Project Name: * Widening of I-95 to Eight lanes from South of SR 1832 (Murphy Road) to South of SR 1811 (Bud Hawkins Road)

Subject: Revised Modification Request for Section 404 Individual Permit, and Modification Request for Section 401 Water Quality Certification and Neuse Riparian Buffer Authorization for the Widening of I-95 to Eight lanes from South of SR 1832 (Murphy Road – Exit 56) to South of SR 1811 (Bud Hawkins Road – Exit 70), in Cumberland County, STIP No. I-5986A. WBS 47532.3.2.

WETLAND AND SURFACE WATER IMPACTS

PERMIT DRAWING
SHEET 1 OF 163

PERMIT DRAWING
SHEET 134D OF 163

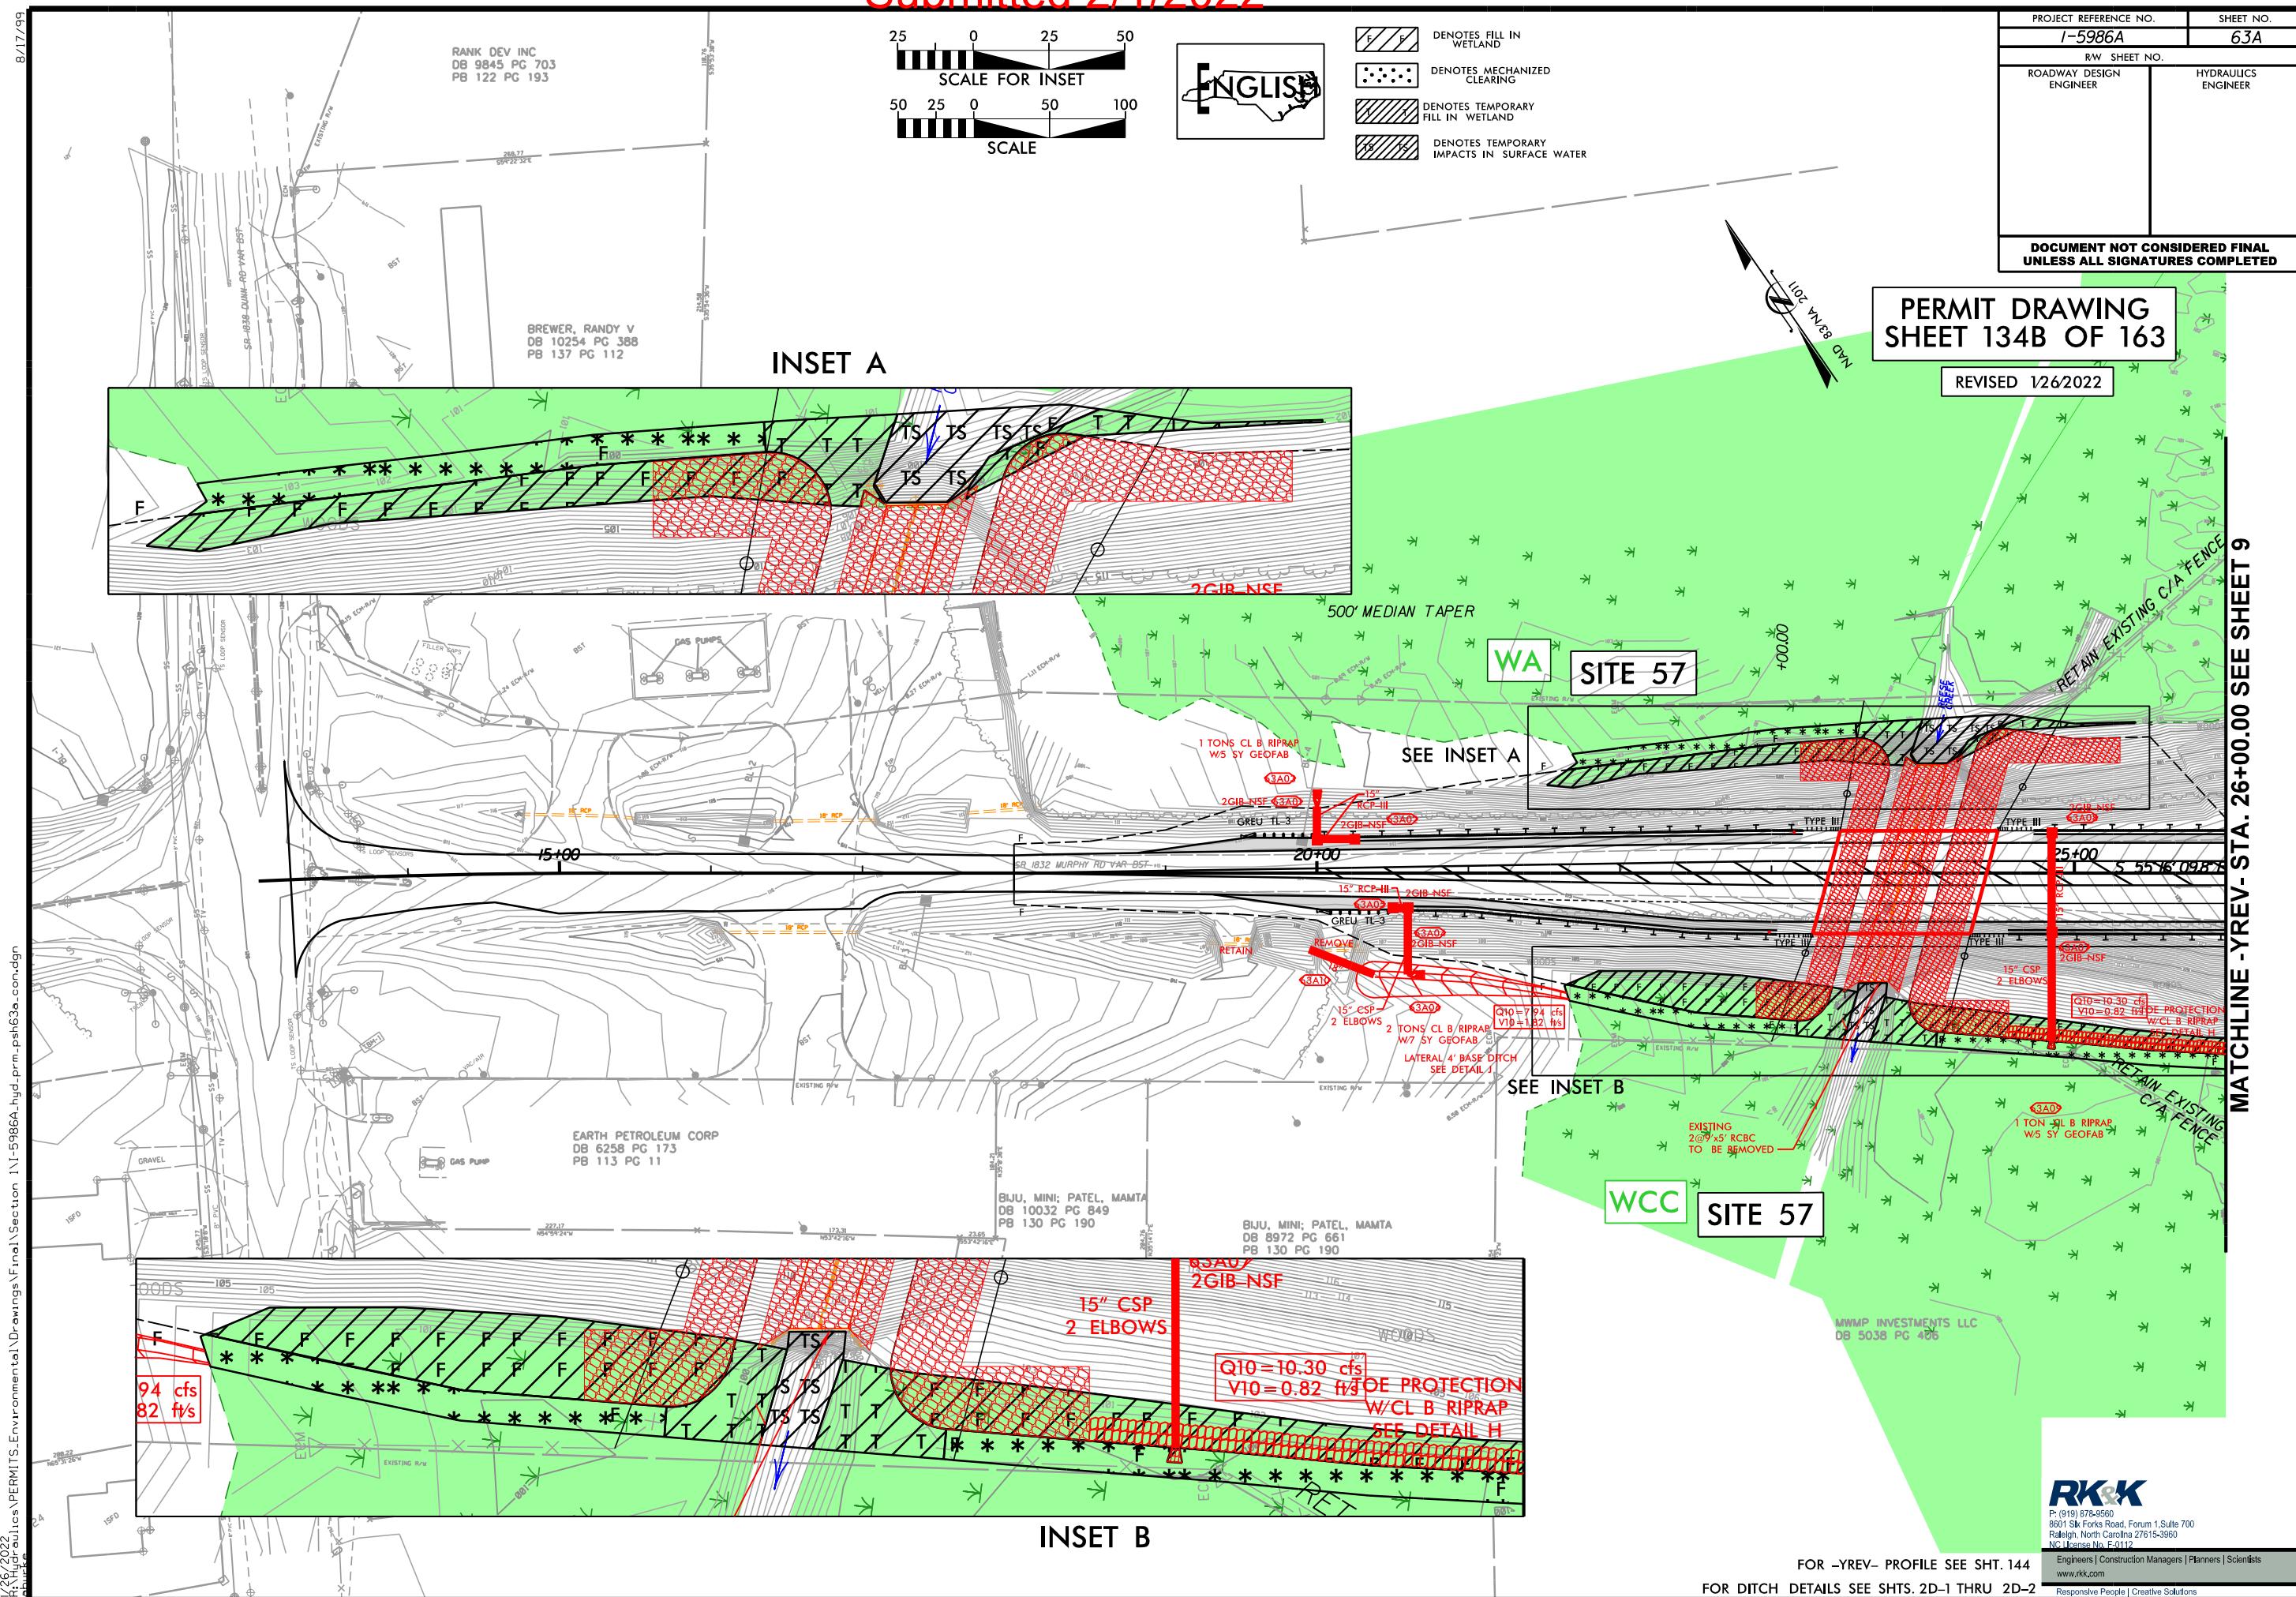
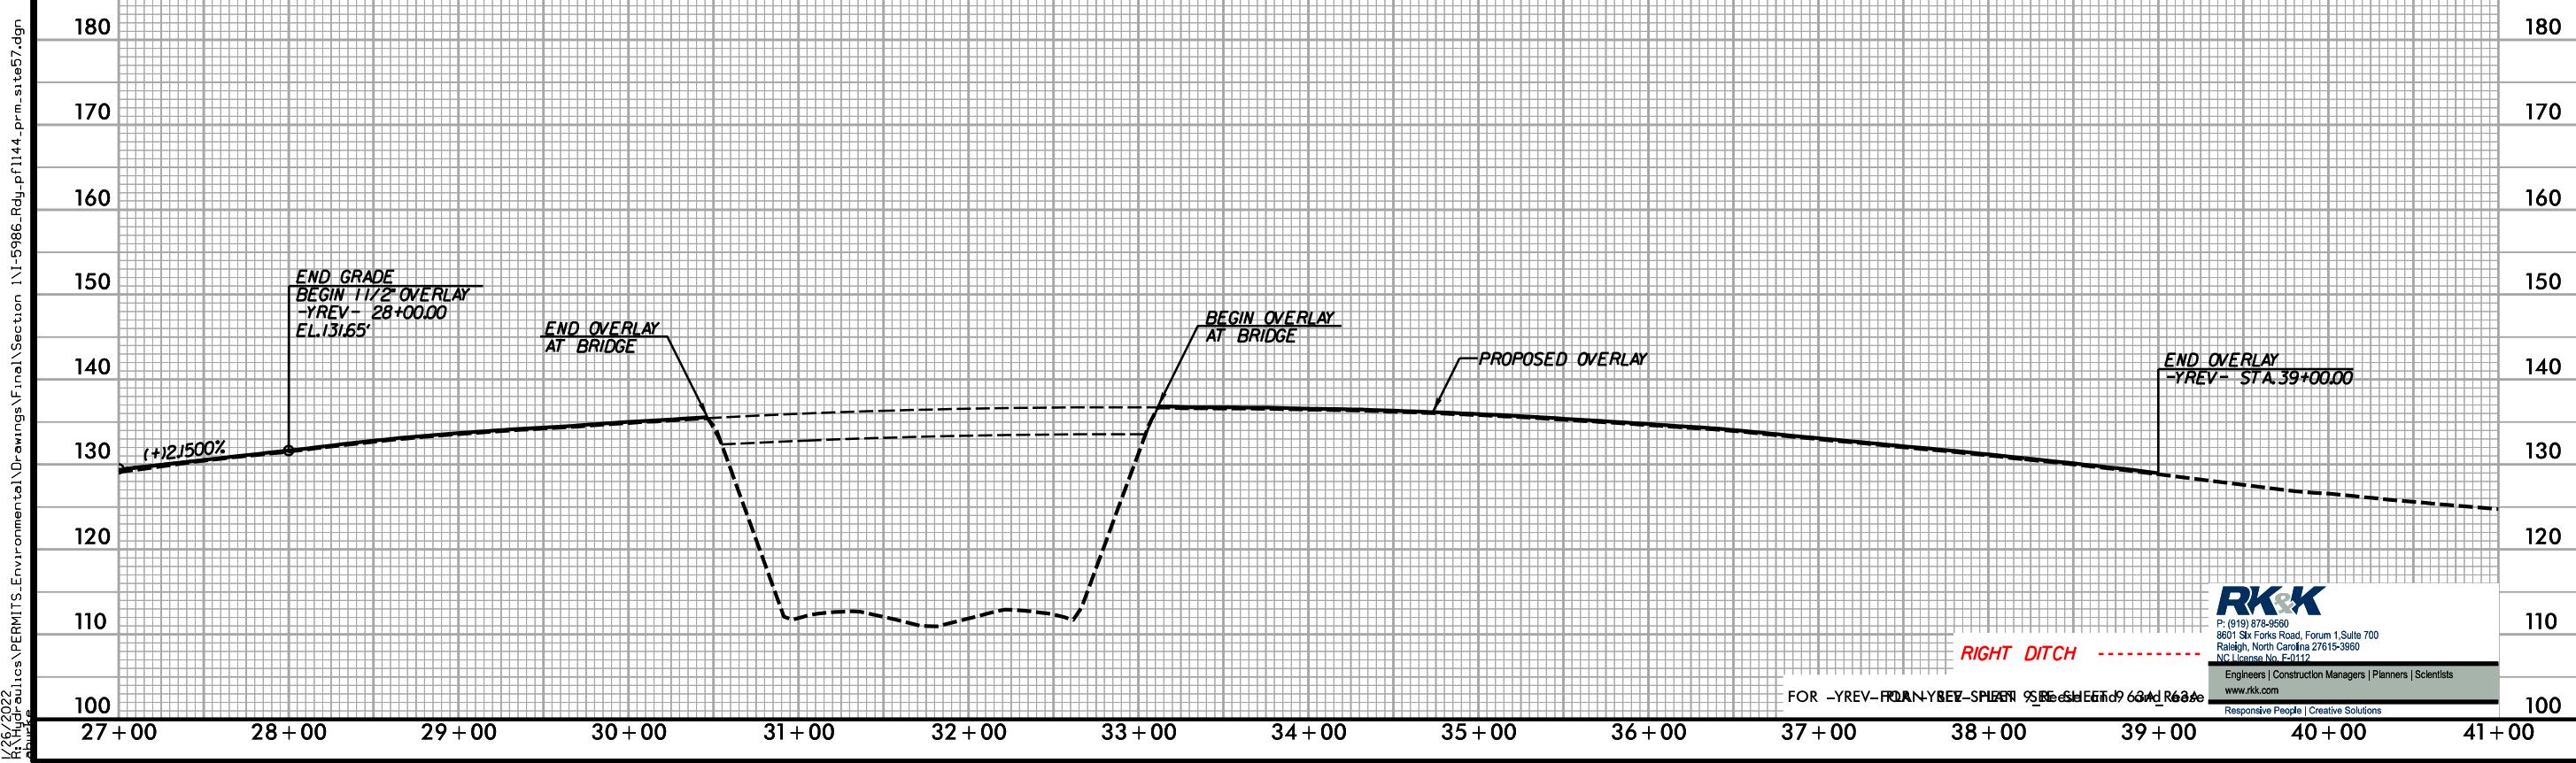
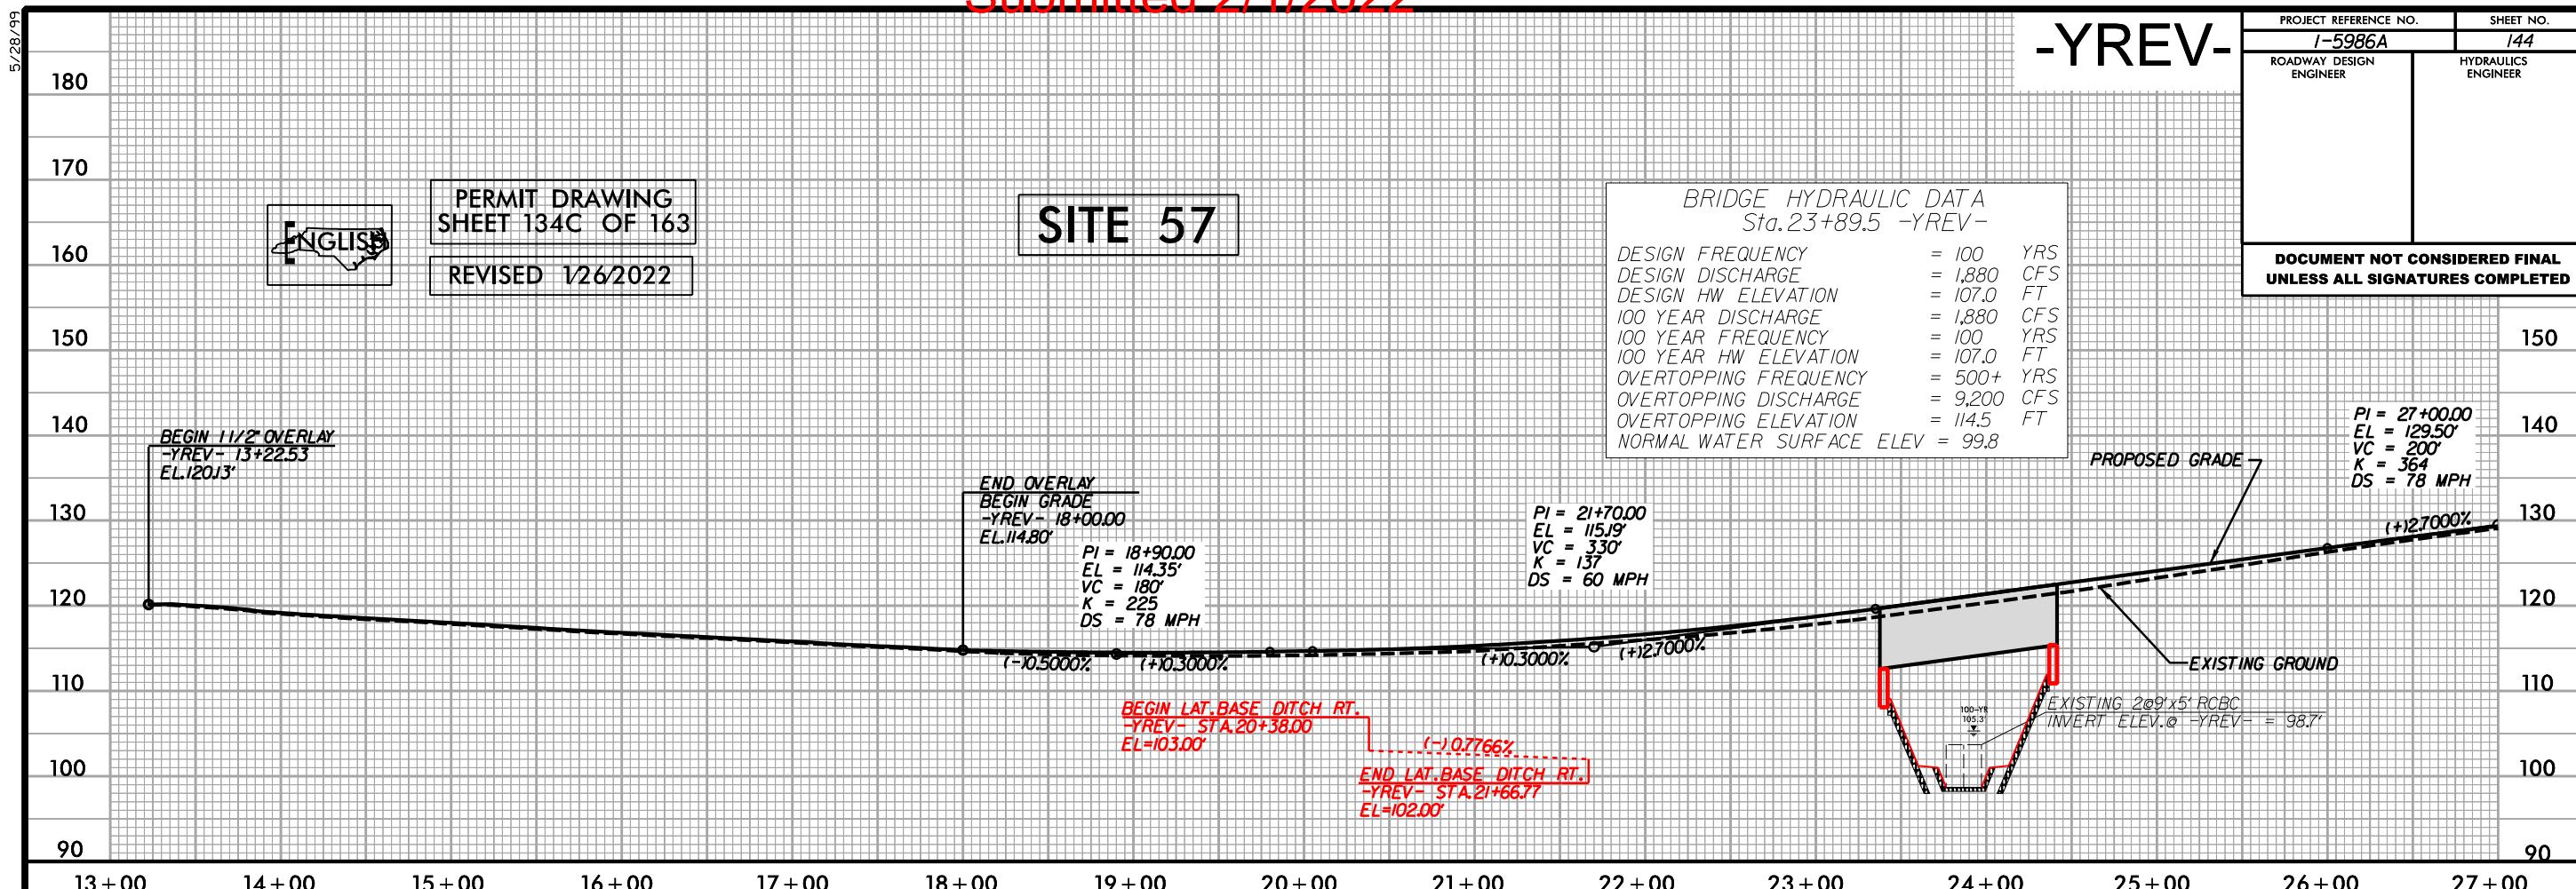
Site 57. This is a new impact site associated with the Reese Creek redesign.

- 0.226 acre in permanent fill in wetlands.
- 0.066 acre in temporary fill in wetlands
- 0.139 acre in mechanized clearing in wetlands
- 78 linear feet in temporary stream impacts
